ET 09-0014

Subject: Docket No. 50-482: Wolf Creek Nuclear Operating Corporation's Response to Request for Additional Information Regarding 10 CFR 50.55a Request I3R-06

**Response to Request for Additional Information Regarding
10 CFR 50.55a (Relief) Request I3R-06**

Figure 1
Inlet piping to safe-end and safe-end to inlet nozzle welds
(Not to scale)

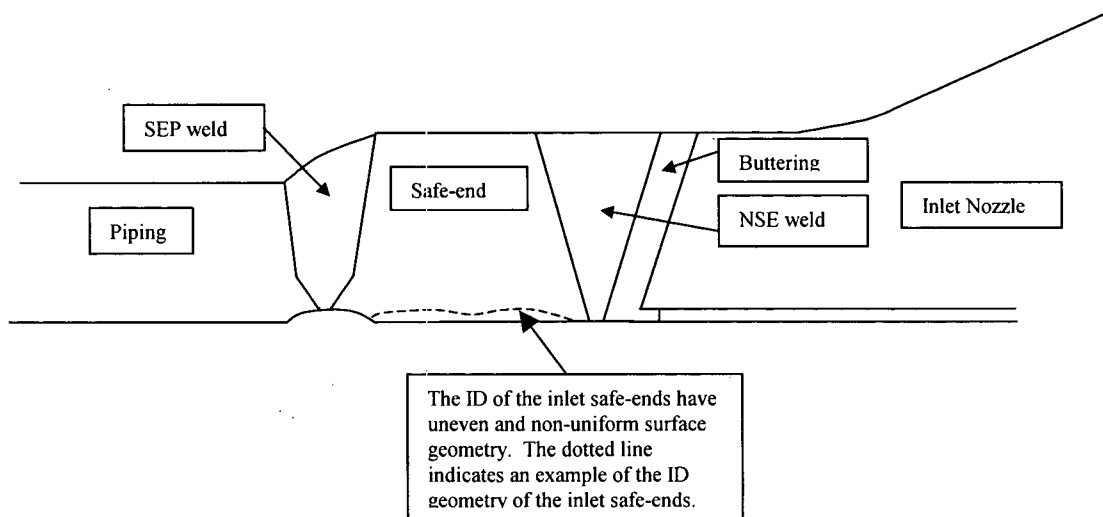
1. *Page 1 of the application identified welds as either Category B-F or Category B-J. Please provide representative sketches of the configurations and identify the weld and base material (carbon steel, stainless steel, Inconel, etc). Include in the sketches the impediments that are preventing the Code-required examinations.*

Note: Vendors are unable to meet the Code requirement for depth sizing of 0.125 inch RMSE for configurations typical of the above when performing examinations from the Inside Diameter (ID).

Nozzle to Safe-end (NSE) welds	Safe-end to Pipe (SEP) welds
RV-302-121-A	BB-01-F102
RV-302-121-B	BB-01-F202
RV-302-121-C	BB-01-F302
RV-302-121-D	BB-01-F402
